ADDENDUM NO: 01

BID PACKAGE NO: Kitchen Work Rebid

PROJECT: North and South Decatur Jr. / Sr. High School Additions and Renovations

PROJECT NO: DATE: 02/16/2024 BY: Emery H. M. Hunt

AD201

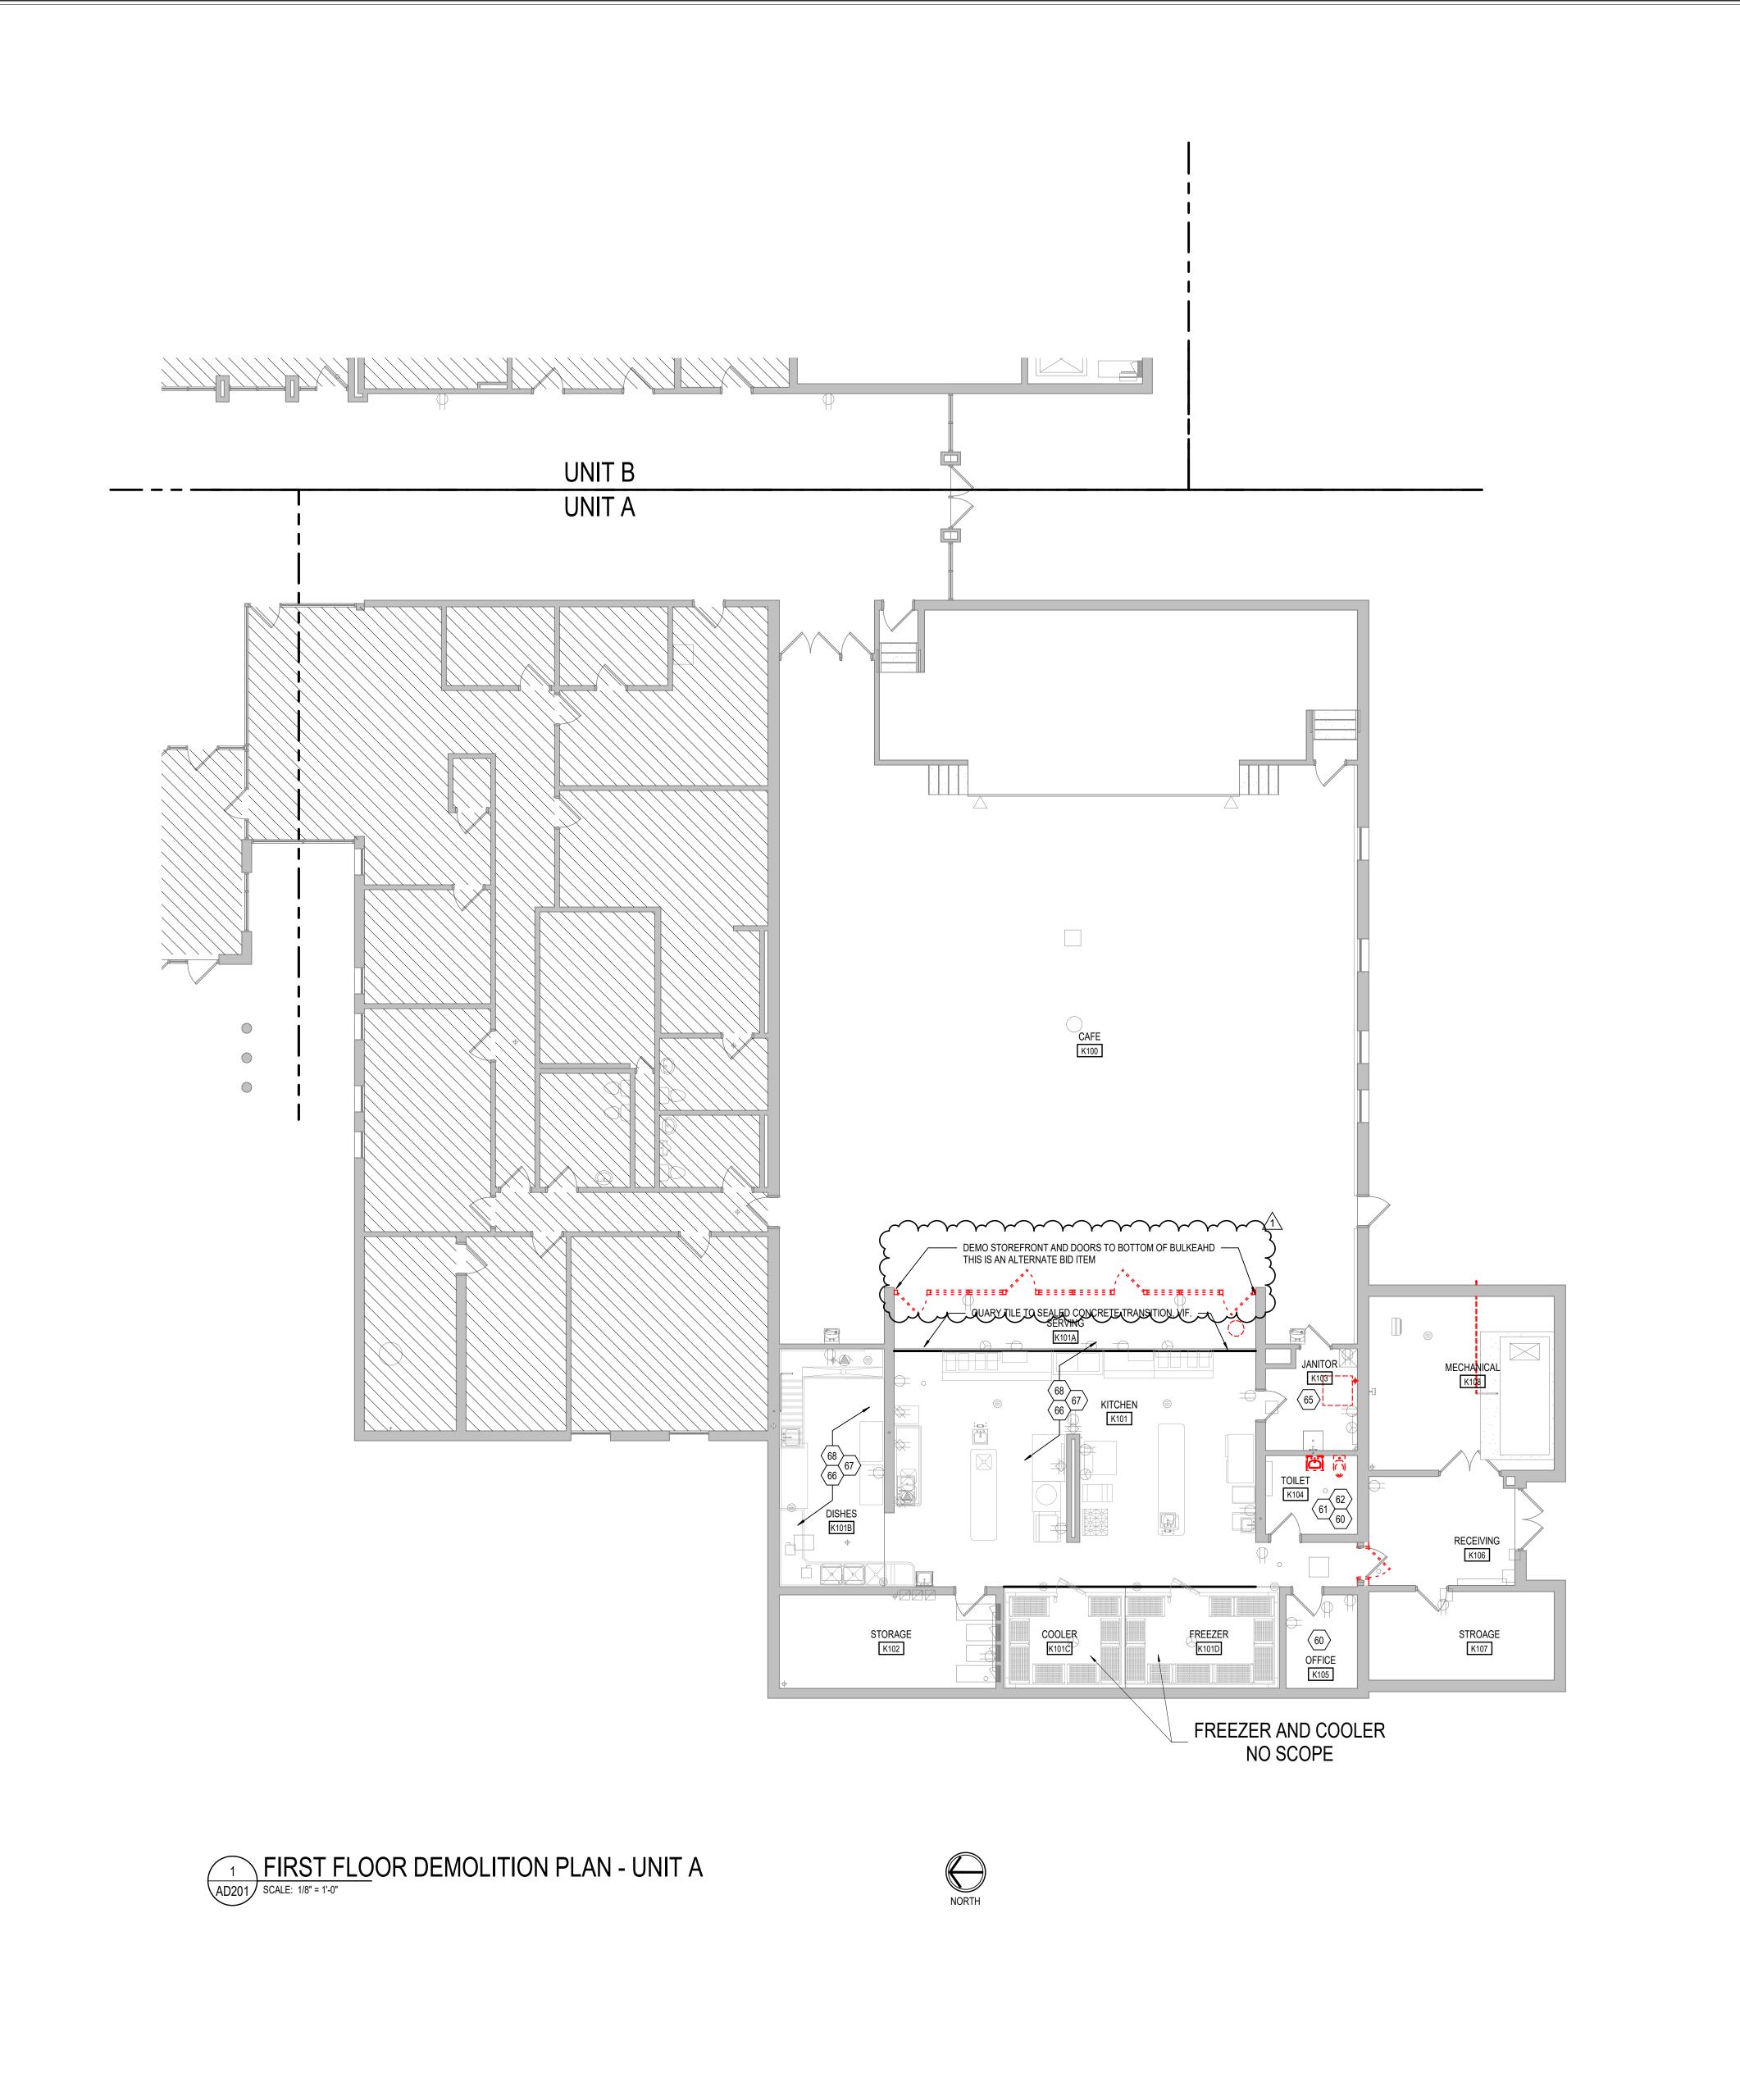
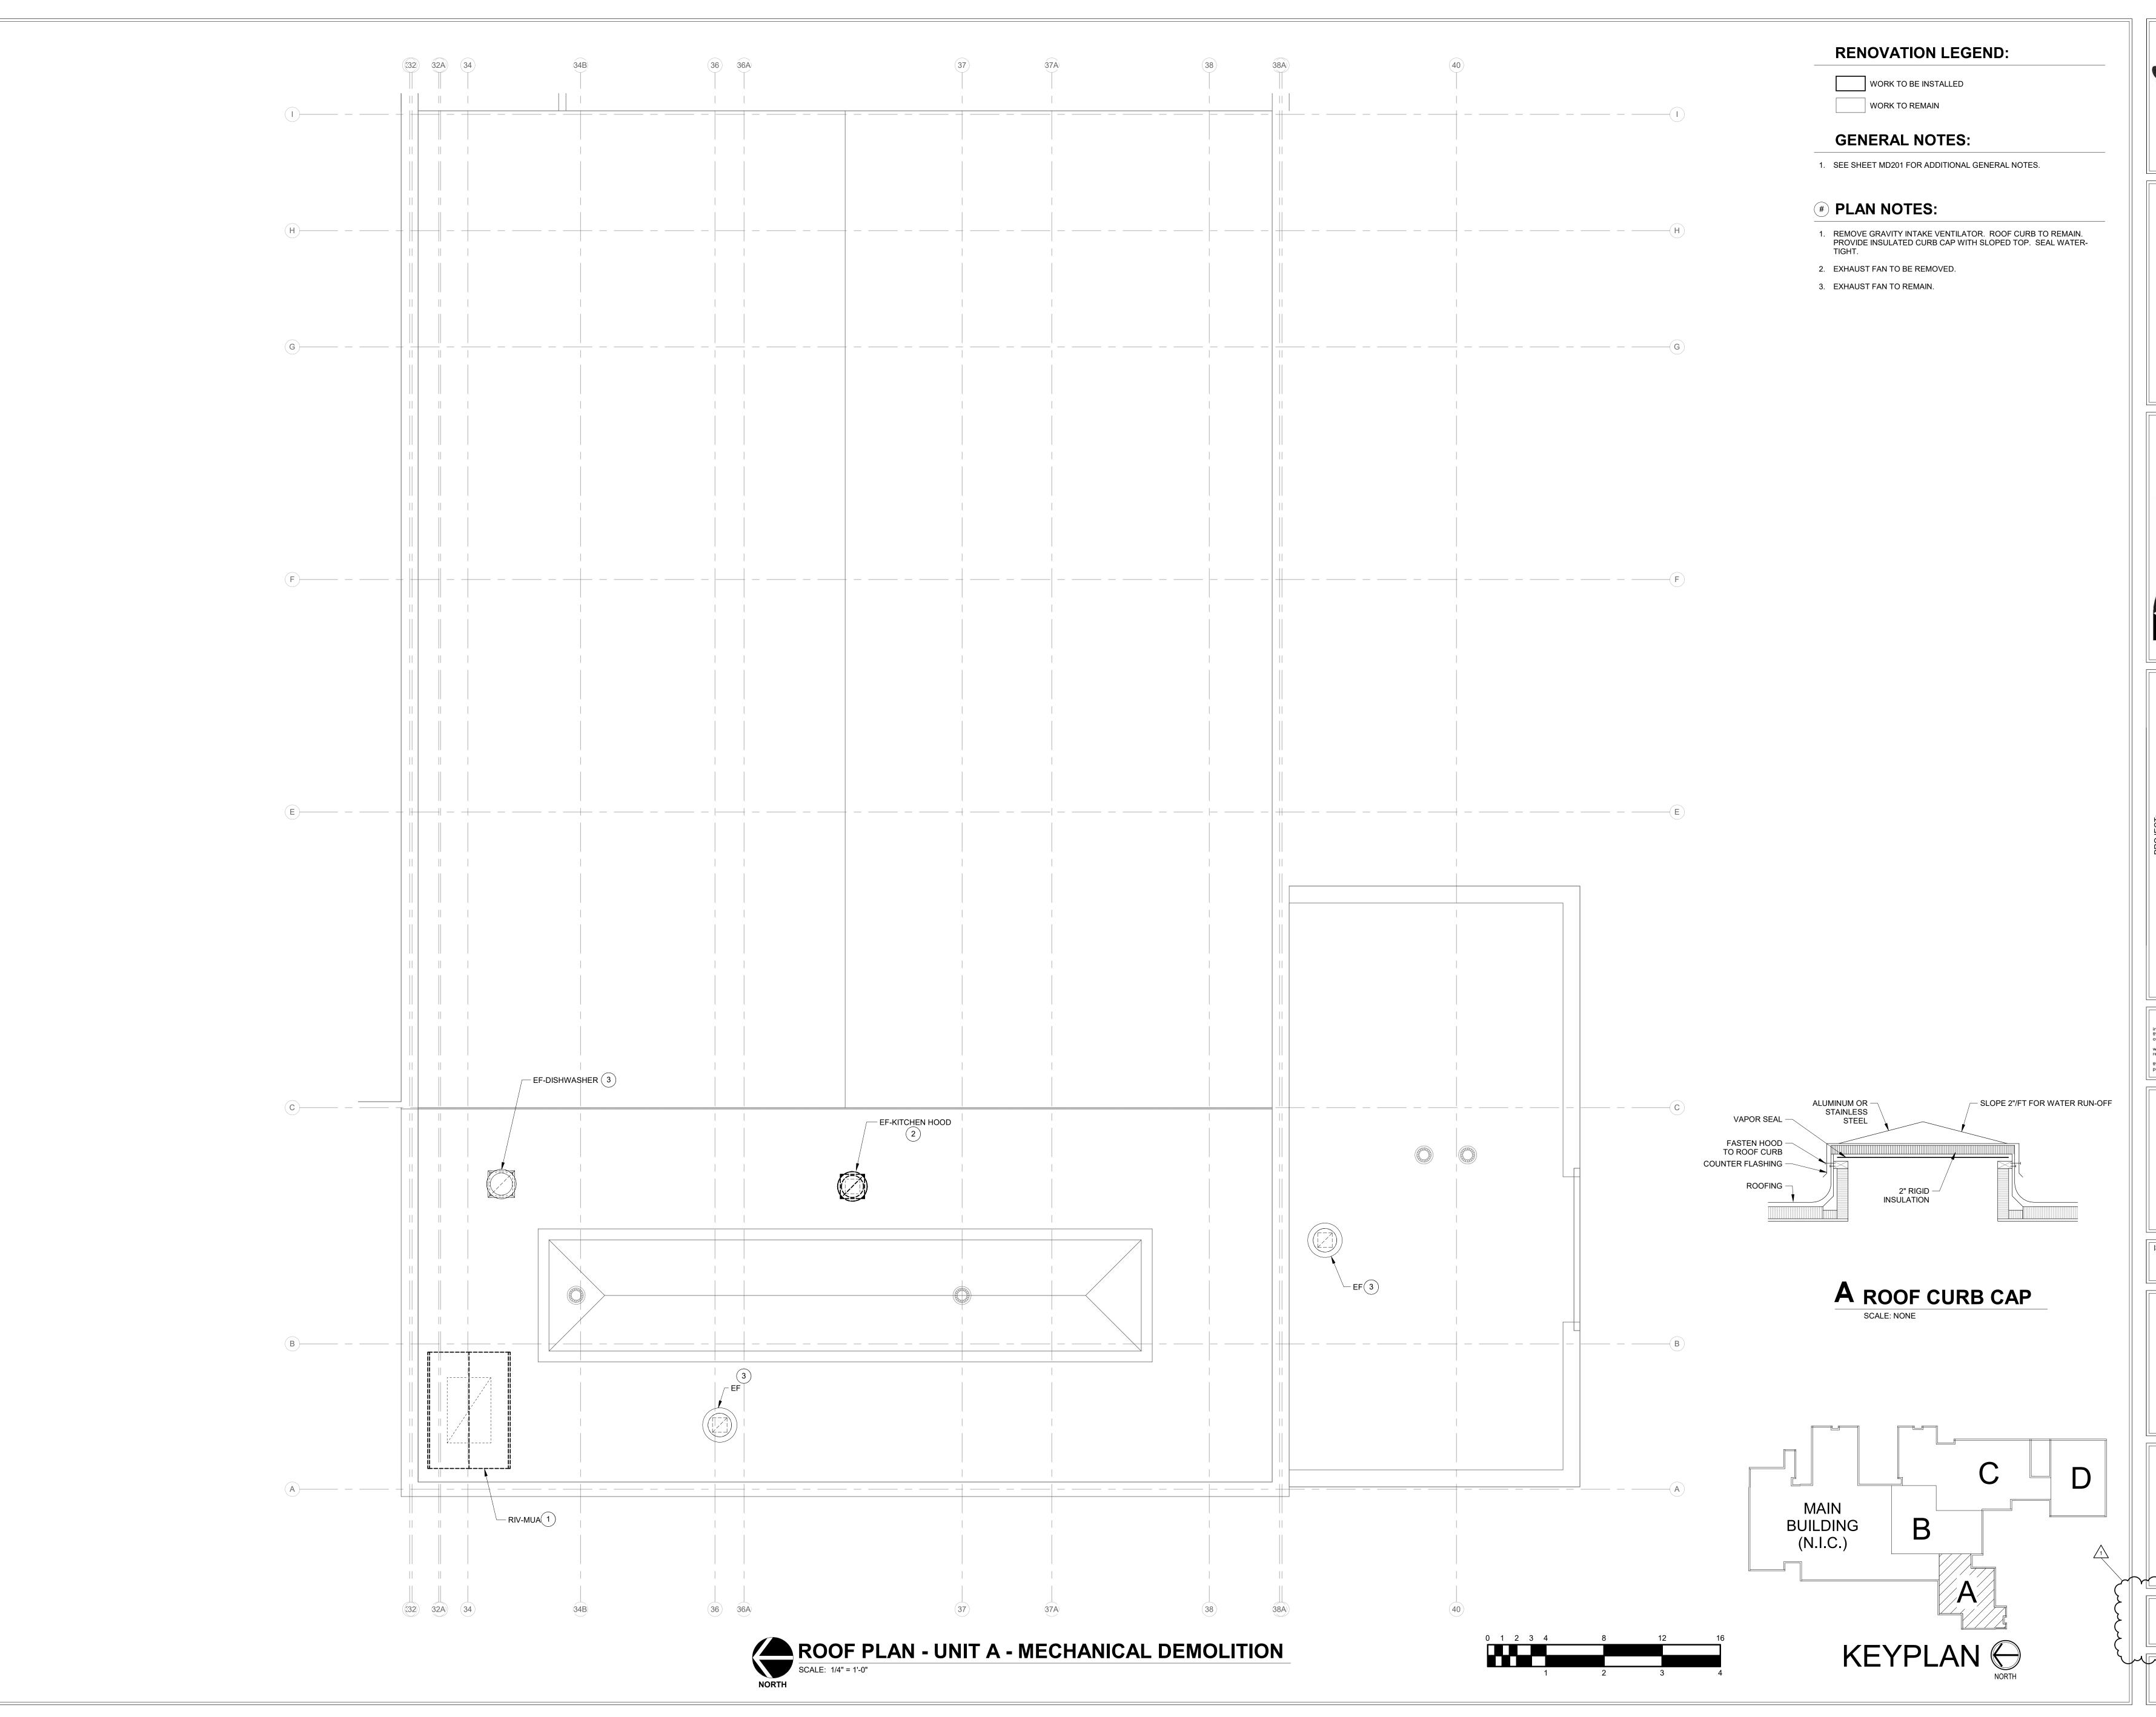
- 4.1 <u>C112 DEMOLITION PLAN</u>
 - A. Remove note to televise existing sanitary line.
- 4.2 AD201 FIRST FLOOR DEMOLITION PLAN UNIT A
 - A. For the alternate bid, show the serving line storefront and doors completely demolished.
 - B. Revise demo note 68
- 4.3 <u>A201 WALL TYPE SCHEDULE & FIRST FLOOR PLAN UNIT A</u>
 - A. Show alternate bid item for replacement of serving line replacement with new CMU wall and doors.
 - B. Revise note 20

MD221 2021061

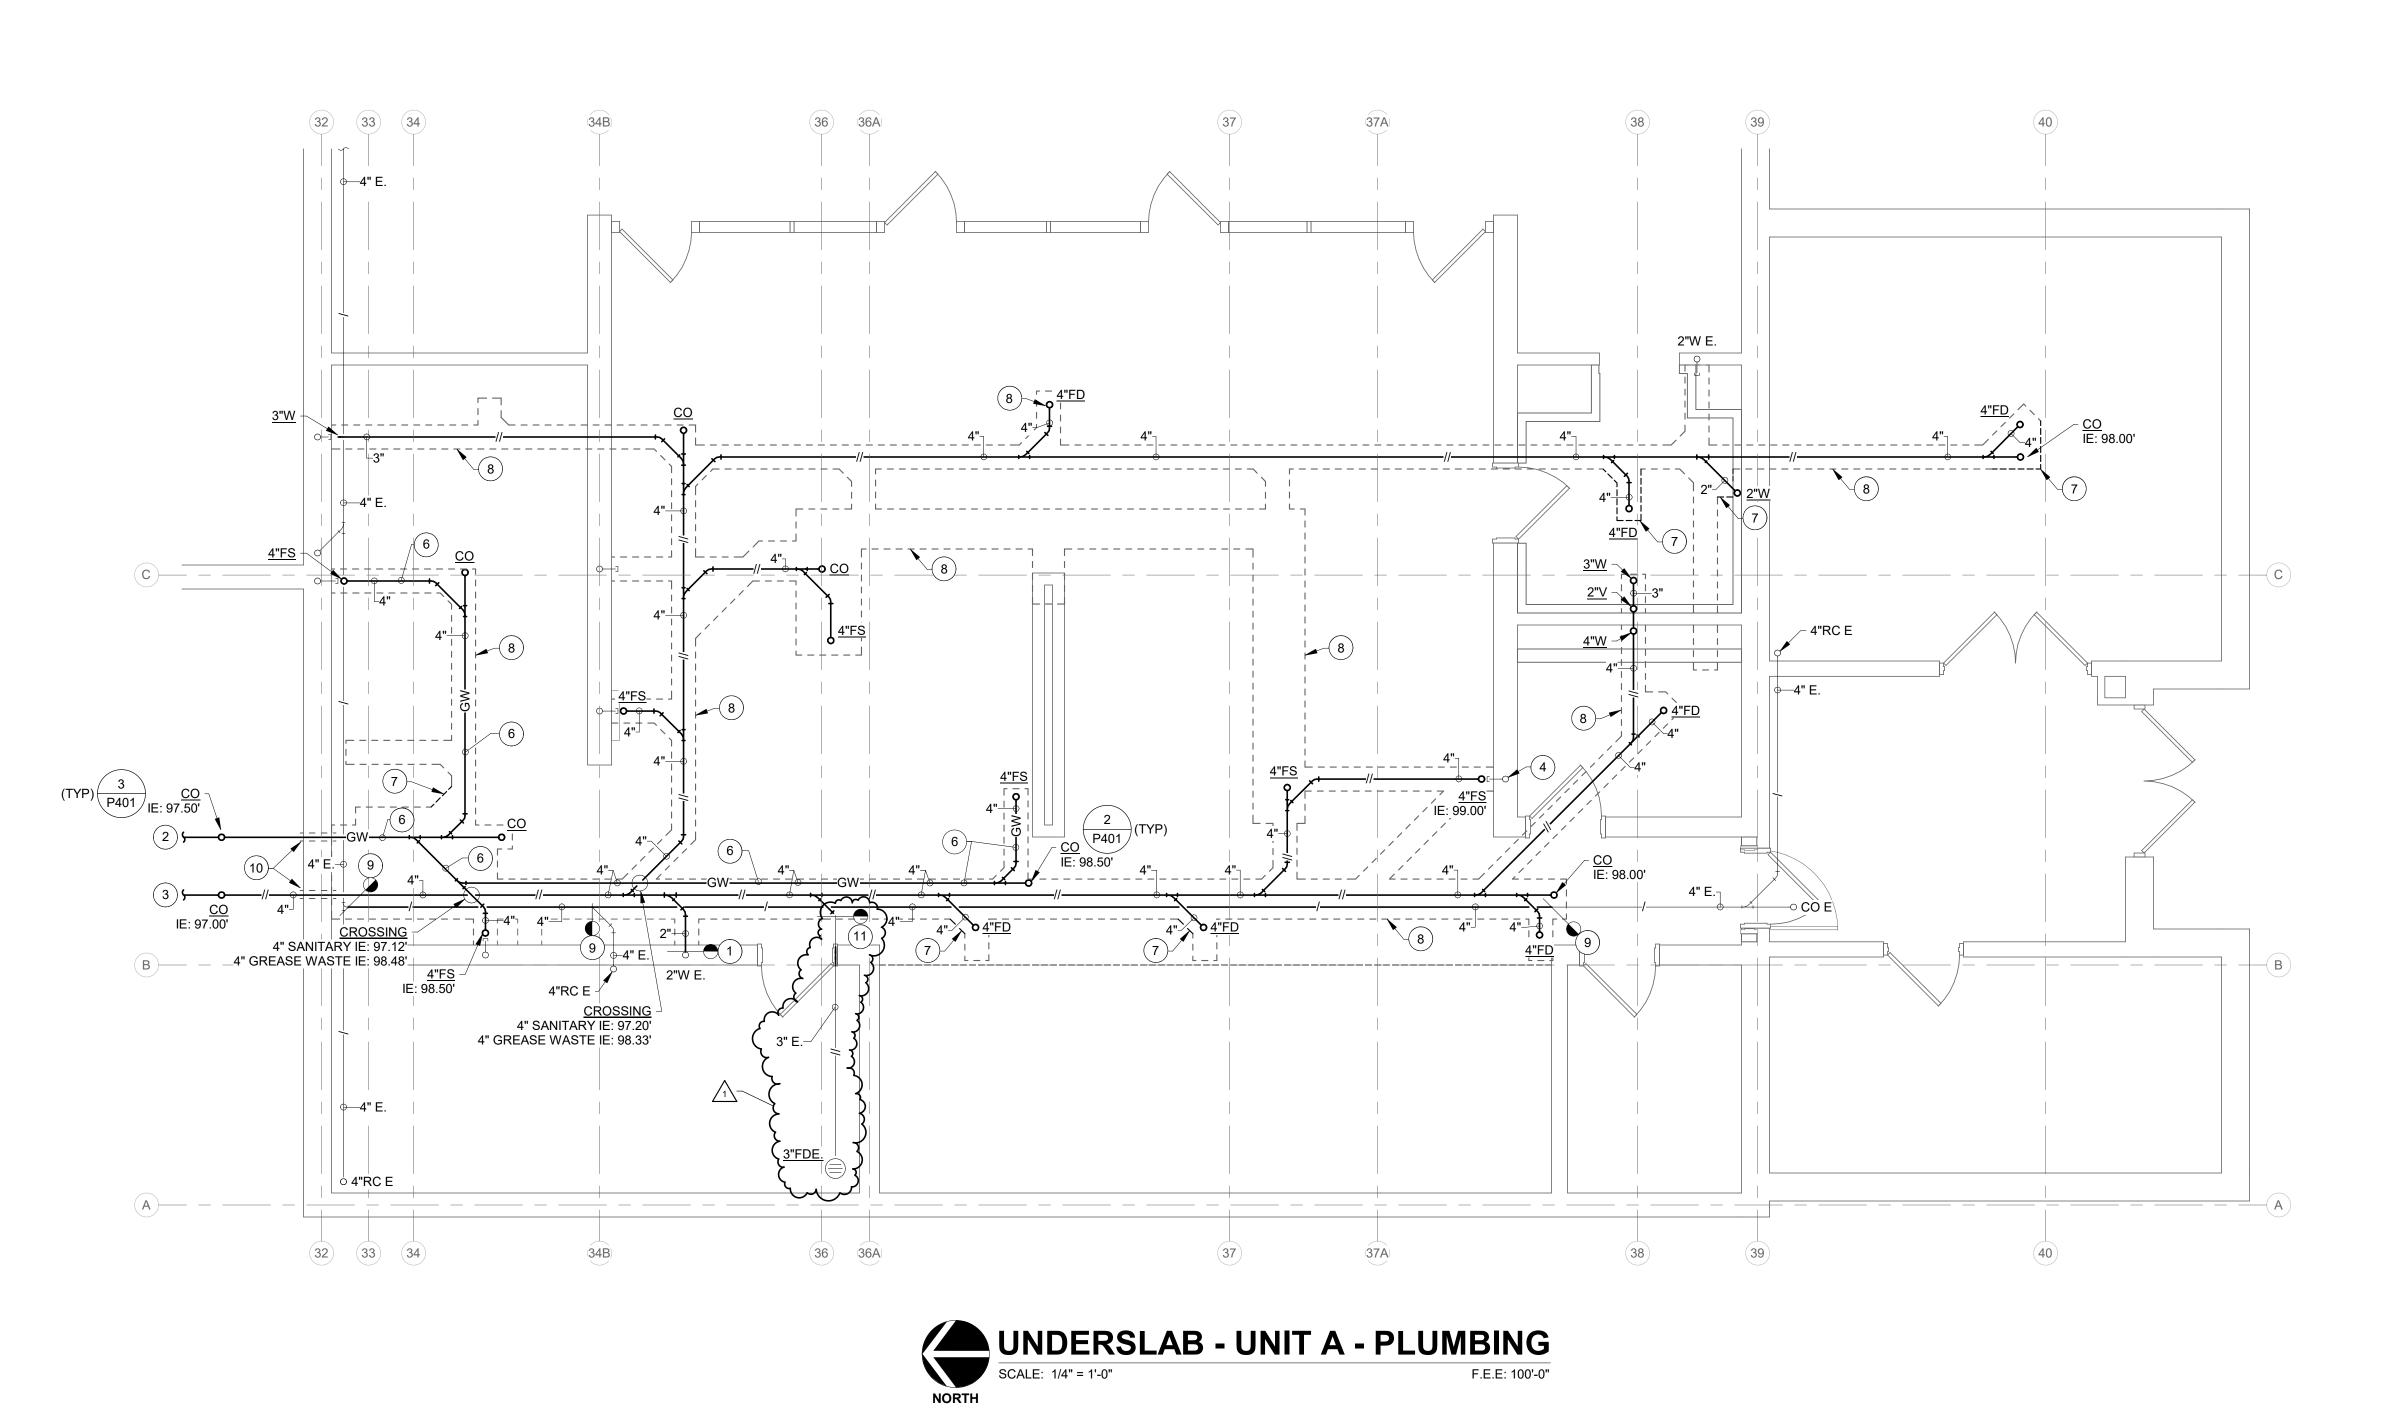
A. Add this sheet in its entirety.
